**EXTENDED POWER UPRATE –
RESPONSE TO REQUEST FOR ADDITIONAL INFORMATION IDENTIFIED
DURING AUDIT OF THE SAFETY ANALYSES CALCULATIONS**

**ANP-2903Q2(NP)
Revision 0**

**St. Lucie Nuclear Plant Unit 1 EPU Cycle
Realistic Large Break LOCA
Summary Report with Zr-4 Fuel Cladding**

Florida Power and Light submitted the RLBLOCA Summary Report to the NRC for review. Section 2.0 contains AREVA NP Inc.'s responses to NRC questions posed during the audit held in Lynchburg, VA on January 30-31, 2012.

Figure 2-2: Example of Power History

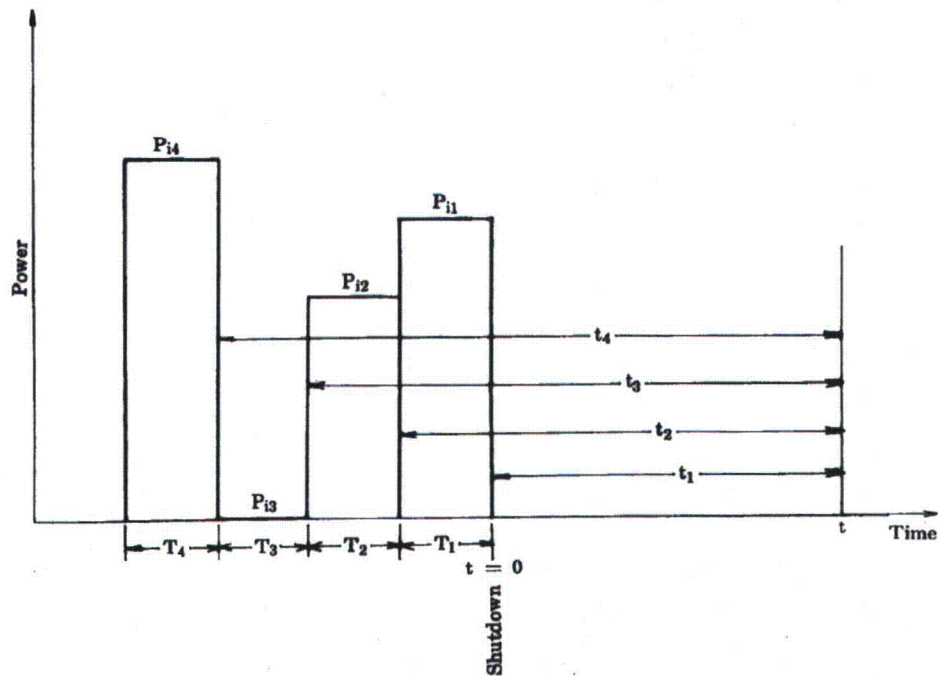
Issue the decay heat response that that was provided to the auditors during their visit.

Figure 2-4: Case 32 PCT Trace

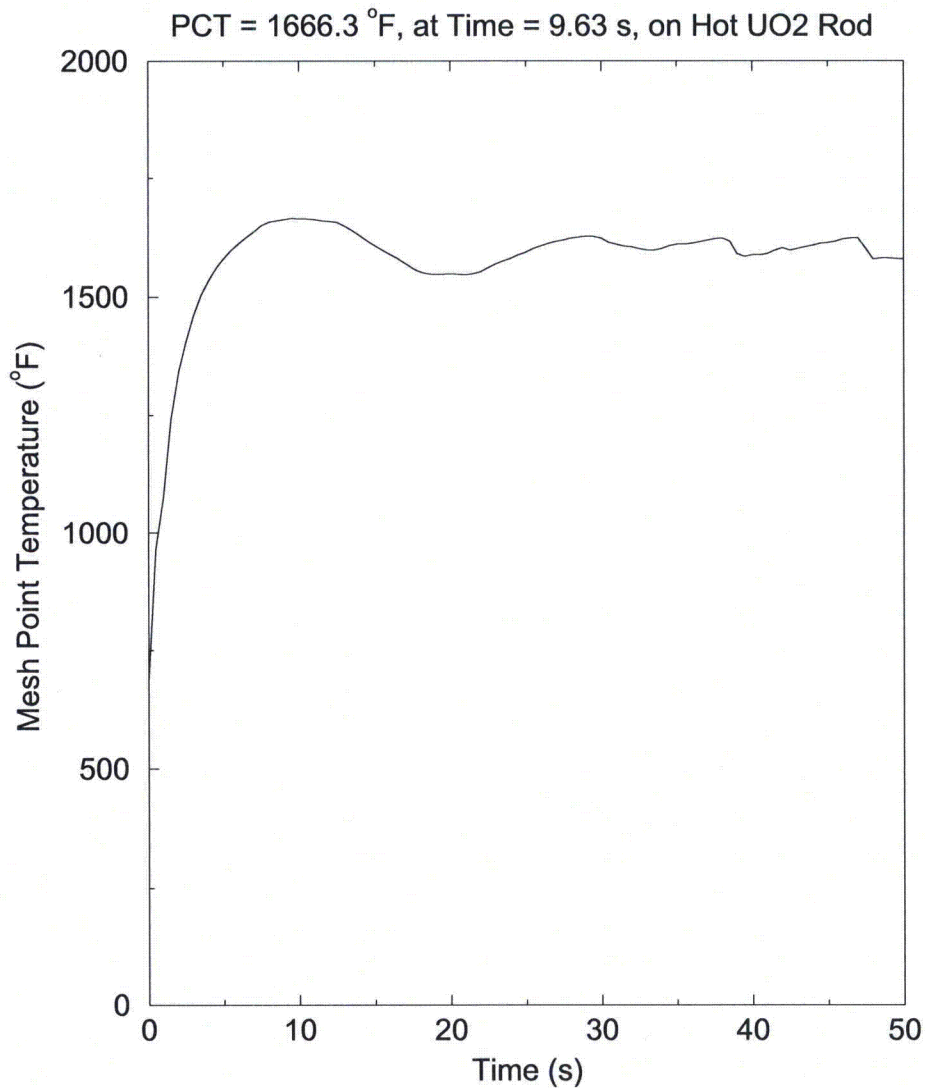
Provide a set of plots for the first 50-seconds of the limiting PCT case and the very late PCT case including:

- a. PCT
- b. Core inlet mass flux
- c. Core exit mass flux
- d. System pressure

The limiting case is Case 32 with a PCT of 1667°F occurring at 9.6 seconds. Figure 2-4 displays the PCT in the fresh UO_2 rod for Case 32. Figure 2-5, Figure 2-6, and Figure 2-7 show the system pressure (upper plenum pressure), the core inlet mass flux, and the core outlet mass flux, respectively, for Case 32. [] Figure 2-8 displays the PCT in the fresh UO_2 rod for Case 46. Figure 2-9, Figure 2-10, and Figure 2-11 show the system pressure, the core inlet mass flux, and the core outlet mass flux, respectively, for Case 46.
